Service Bulletin

no. 16

Subject CRANKSHAFT REBUILD KIT

Date June 15th, 1974

Subject ENGINE NOISE REDUCTION

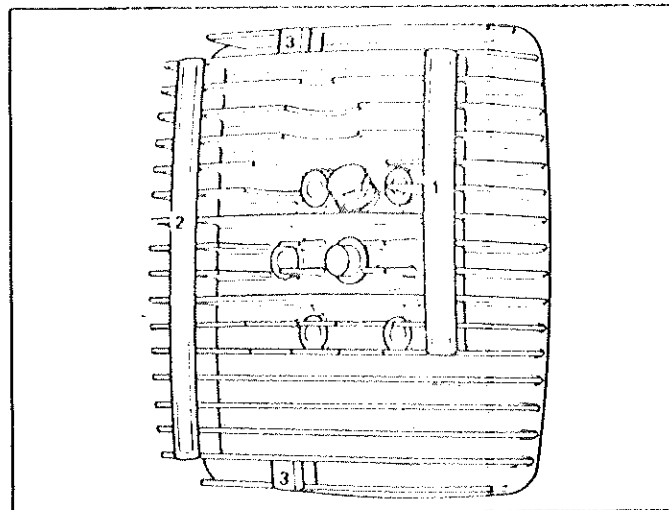
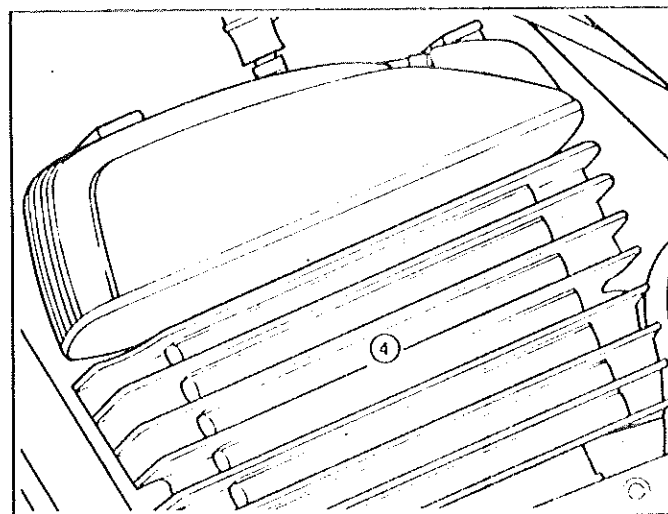
In order to lower the sound level of the engine power head, the '74 T'NT's noise dampers can be fitted to all other Can-Am motorcycle engines.

- ① Damper No 734-011-000 (short) fit rear of cylinder head. 1 -
- ② Damper No 734-011-001 (long) fit front of cylinder head. 1 -
- ③ Damper No 734-011-002 (small) fit both sides of cylinder head. 2 -
- ④ Damper No 734-011-003 should be inserted between cylinder fins. 12 -

Subject CLUTCH DRAG

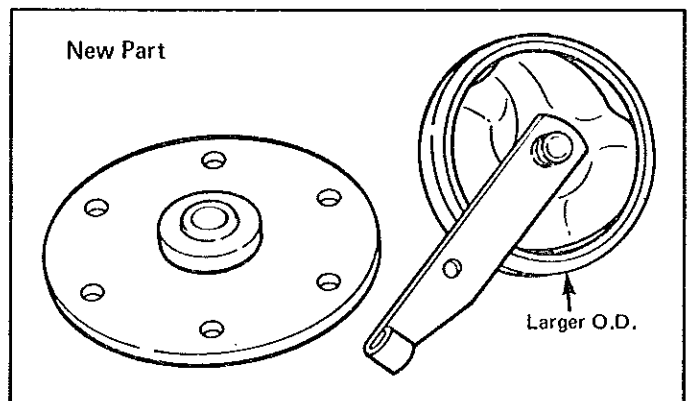
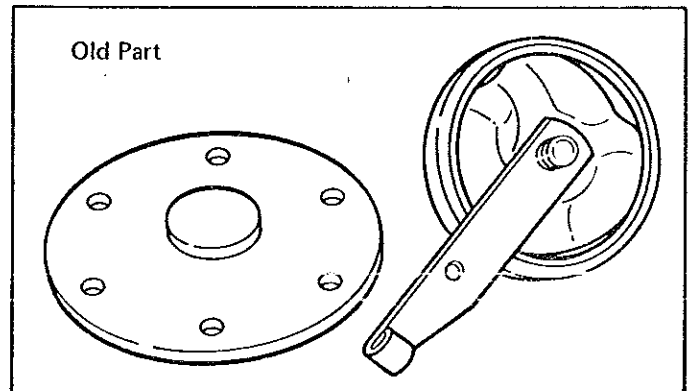
In order to correct slight clutch drag, a new clutch release cam assembly has been designed and is standard on all 74 T'NT 175cc.

This cam assembly can be installed on all other models. Find below the list of parts to be replaced:

Part name	Old part no.	New part no.
Plate, clutch spring retaining	420-259-590	420-259-596
Clutch release cam	420-259-615	420-259-619
Clutch adjustment screw	420-241-790	420-241-791
Clutch release bearing	420-932-990	
	420-259-600	420-259-705

NOTE: On 125cc T'NT 74 only, if the steel plates are warped excessively, align the plates so that the warped part on each plate faces the same way and is in the same position.

Subject **SHIFT SHAFT SNAPRING**
 Models **ALL 1973 PLUS 1974 MX**
 Serial nos. **ALL**
 Date **AUGUST 6th, 1975**

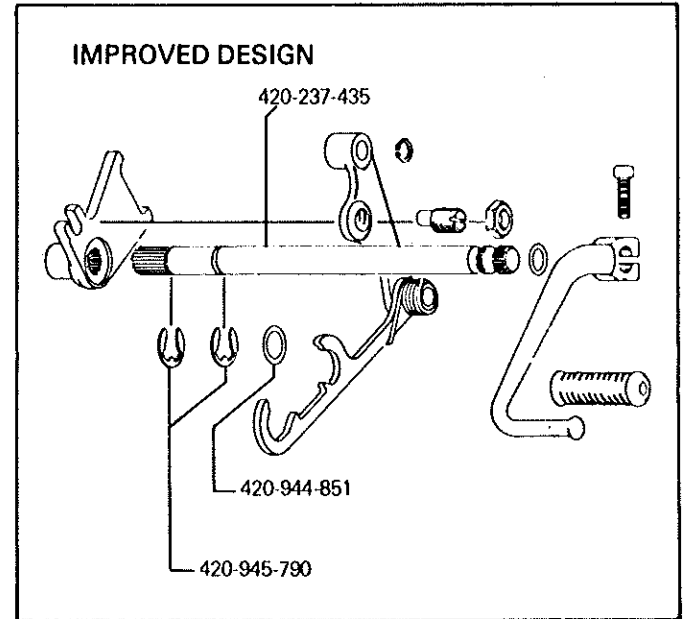
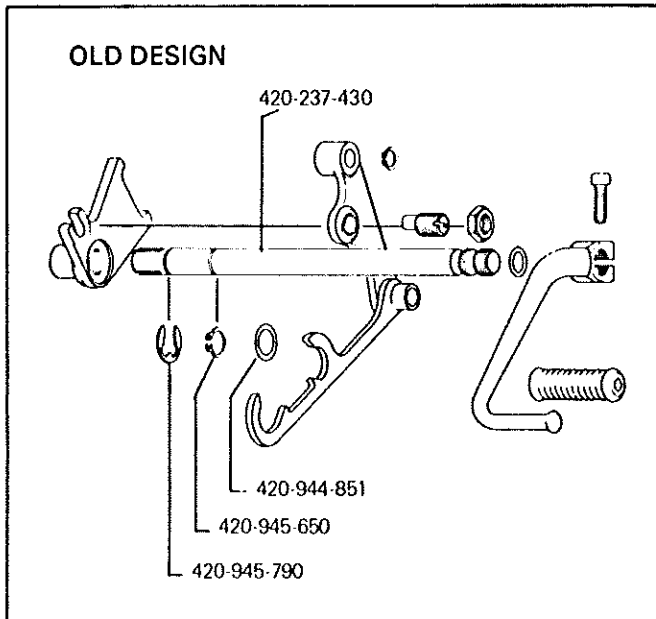
Snapping, p / n 420-945-650, has been known to come out of the locating groove in shift shaft, p / n 420-237-430, allowing the shift shaft to slide outwards and away from the actuator lever spline.

The remedy for this problem is to install shift shaft, p / n 420-237-435, with the larger clip, p / n 420-945-790.

○ NOTE: Be sure to include thrust washer, p / n 420-944-851.

Subject LEFT SIDE PANEL BRACKET
Models 1974
Serial nos. ALL
Date July 18th, 1974

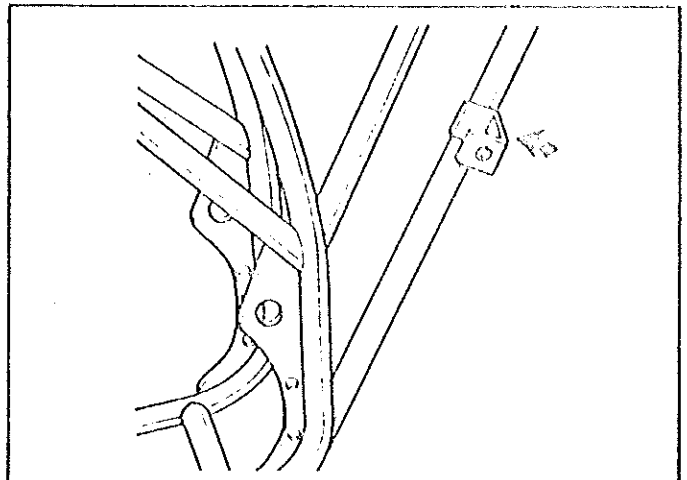
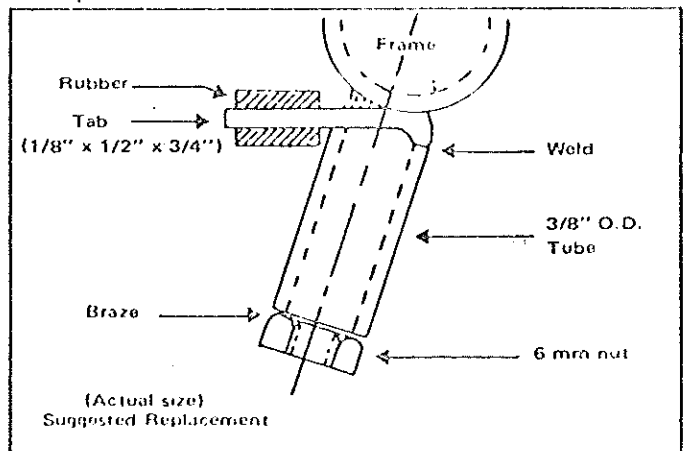
In the case of breakage of the left side panel bracket, a replacement is now available under part number 746 063-001.

This bracket can be gas or heli-arc welded, but care should be exercised not to overheat the air box area close to the frame. A heat shield should be employed between airbox and frame tube to prevent airbox from melting during welding.

Subject TRANSMISSION ACTUATING LEVER
 Models All
 Serial nos. All
 Date December 6th, 1974

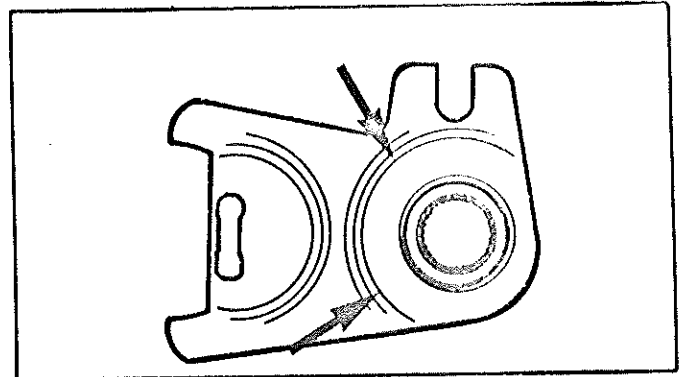
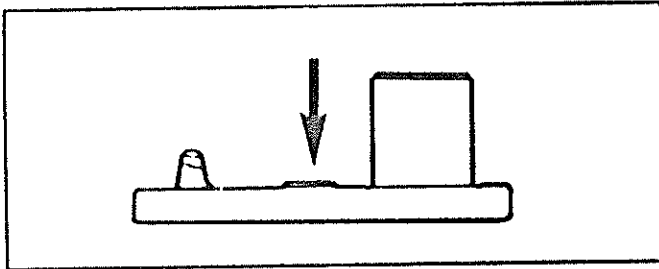
PROBLEM: When fitting a new transmission lever, p/n 420 258 575, you may find that the shifter shaft has no end play, and that the shifter level will not return to its static position properly.

PROBABLE CAUSE: The new actuating lever has a slight ridge on the outer thrust washer support face (see drawing) that has eliminated the necessary clearance.

SOLUTION: Using a grinder (eg: Dremel), remove the ridge until the thrust washer sits flatly in position.
